ENGINE SYSTEMS, INC.

Subject: 10CFR21 Reporting of Defects and Non-Compliance -
Engine Systems, Inc. Report No. 10CFR21-0100, Rev. 0

EMD Water Pump, P/N 8324589

**10CFR21 REPORTING OF DEFECTS
AND NON-COMPLIANCE**

Photo 1: Water Pump Returned by Customer
(note impeller fin orientation)

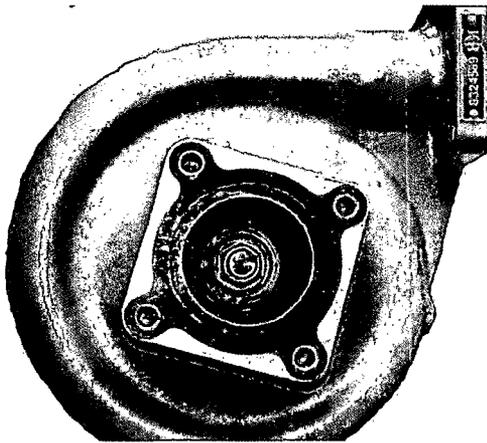
It was reported by Grand Gulf that "while troubleshooting low Div III DJ jacket water pressure it was discovered that the wrong impeller was supplied in the P81C007A pump. The supplied impeller was intended to rotate in the opposite direction as the pump rotation. This appears to be the cause of low jacket water pressure in the A engine."

Subsequently, the water pump was returned to ESI for further inspection. It was apparent from a visual inspection that the incorrect impeller was installed for this pump. P/N 8324589 corresponds to a right hand rotation, left bank water pump for use on a 12-cylinder EMD 645E4 or E4B engine. As shown in Photos 1 and 2 below, the housing corresponds to a right hand rotation pump, but the impeller is for left hand rotation. Figure 3 shows the correct impeller for a right hand rotation pump.

Figure 4: Correct Housing and Fin Orientation for LH Rotation

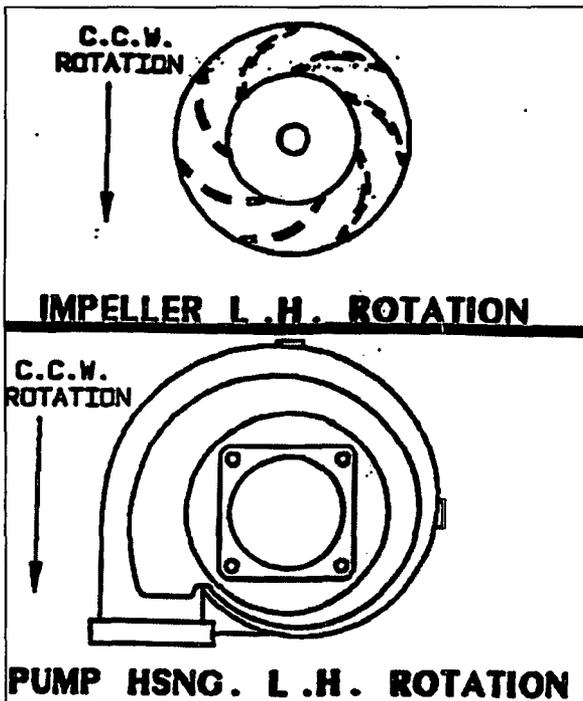
ESI recommends that as a precaution, all customers with an EMD water pump in stock which was supplied by ESI prior to April 2000 should perform a visual inspection to ensure the correct impeller is installed. A pump which has been installed on the diesel engine is considered acceptable based on successful operation of the diesel engine. The impeller inspection is easily performed, without disassembly, by looking into the inlet port of the pump to confirm the orientation of the impeller matches the pump housing. A listing of the various part numbers supplied prior to April 2000 is included in Table 1. Figures 4 and 5 contain visual guidance to ensure the impeller corresponds to the installed pump housing.
